[Docket No. 97-SW-60-AD]

Airworthiness Directives; Sikorsky Aircraft-Manufactured Model CH-54A Helicopters

ACTION: Notice of proposed rulemaking (NPRM).

Columbia Helicopter; Heavy Lift; Silver Bay Logging; Docket No. 97-SW-60-AD.

Rework of Second Stage
Lower Planetary Plate (6435-20229-102)
Figure 1

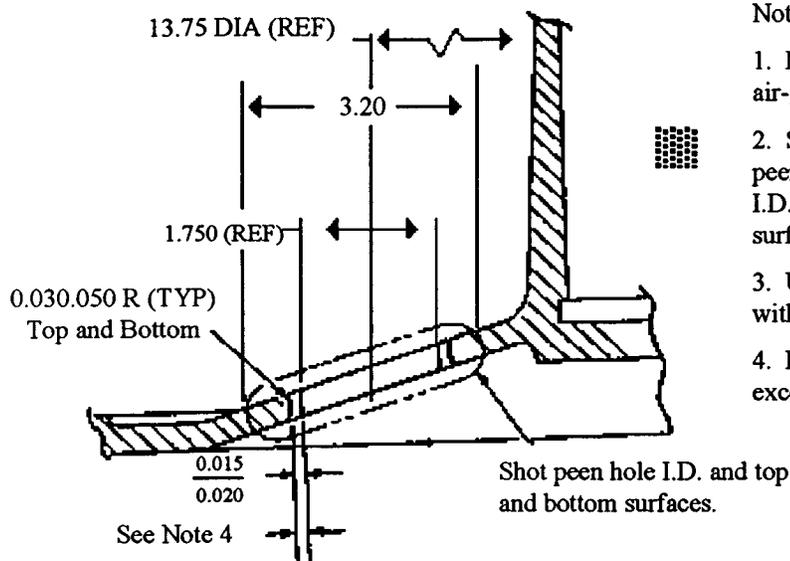
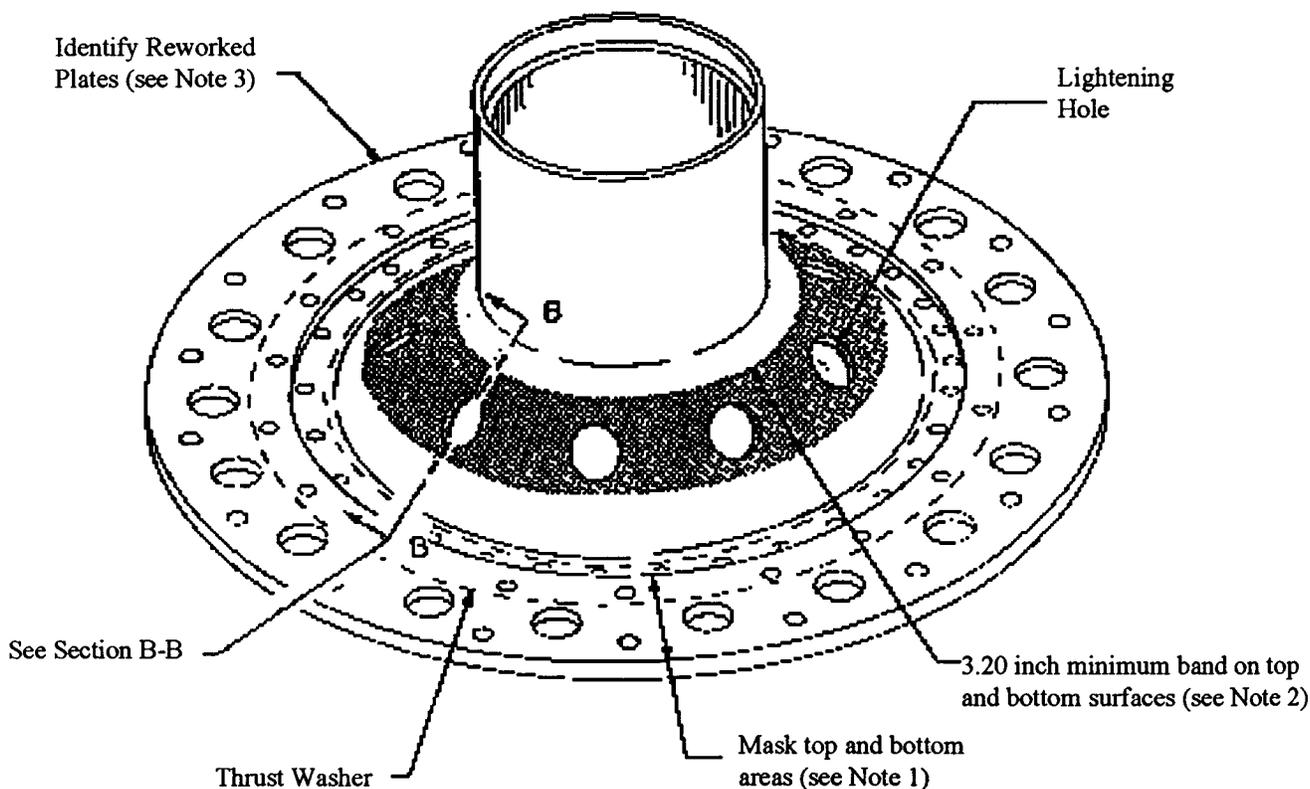
(i) Locate the center of each 1.750 inch-diameter lightning hole and machine holes 0.015 to 0.020 oversize on a side (0.030 to 0.040 diameter oversize). Machined surface roughness must not exceed 63 microinches AA rating (see Figure 1).

(ii) Radius each hole 0.030 to 0.050 inches on each edge as shown in Figure 1.

(iii) Mask the top and bottom surfaces of the plate to expose 3.20 inch minimum width circumferential band as shown in Figure 1.

(v) Shot peen exposed surfaces and inside and edges of lightening holes to 0.008—0.012A intensity. Use cast steel shot, size 170; two hundred percent coverage is required. Use the tracer dye inspection method to ensure the required coverage. Also, visually inspect the shot peened surfaces for correct shot peen coverage. Inspect the intensity of the shot by performing an Almen strip height measurement.

(viii) Identify the reworked plate by adding "TS-107" after the part number using a low-stress depth-controlled impression-stamp with a full fillet depth of not more than 0.003 inch (see Figure 1).

Borescope Inspection of
Second Stage Lower Planetary Plate
Figure 2

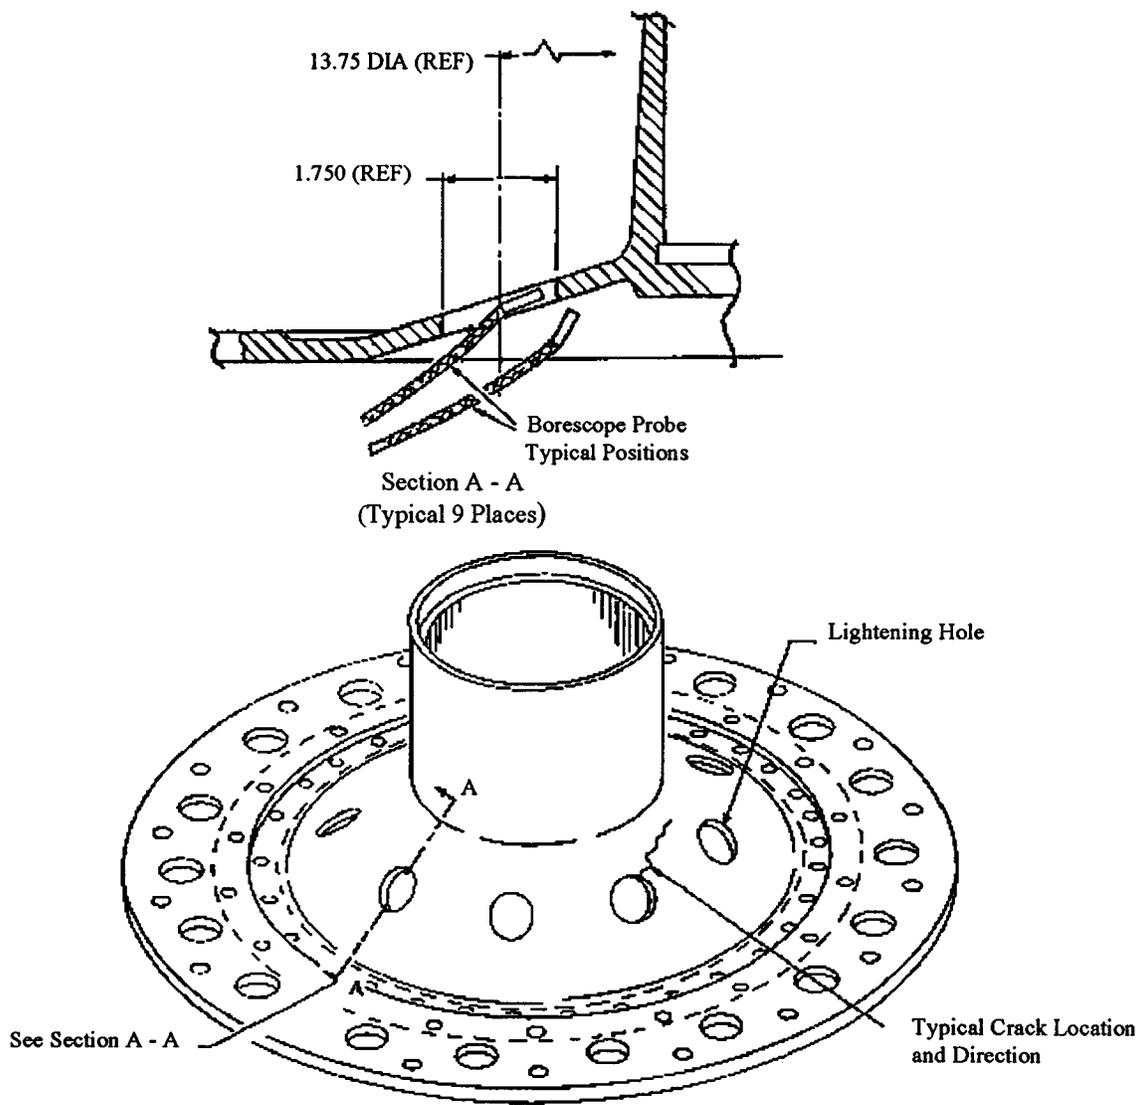
not to exceed 70 hours TIS, accomplish the following:
(1) Inspect the plate for a crack in the area around all nine lightening holes using a

Borescope or equivalent inspection method (see Figure 2).
(2) If a crack is found, replace the plate with an airworthy plate.
